DSOX4032A-01

S E R V I C E   N O T E

4000 X-Series Scopes

A replacement of the power supply cover is needed when the cabinet assembly is replaced.

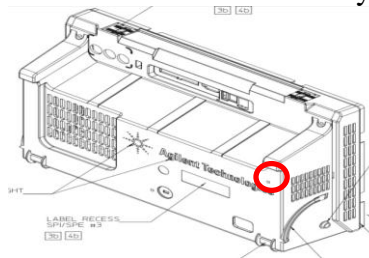
Solution/Action:
1. If the cabinet assembly (54709-64401) needs to be replaced, check if it is the old revision or the new revision
   a. Old revision has 3 screw holes

b. New revision has 4 screw holes

Old revision cabinet

New revision cabinet

2. If the cabinet assembly is the new revision, proceed with repair as normal
3. If the cabinet assembly is the old revision
   a. Replace the power supply cover (54695-00103) with new revision
   b. Replace cabinet assembly as usual (54709-64401)
   c. Insert screw (0515-0380) into the new screw hole on the cabinet assembly (circled below)
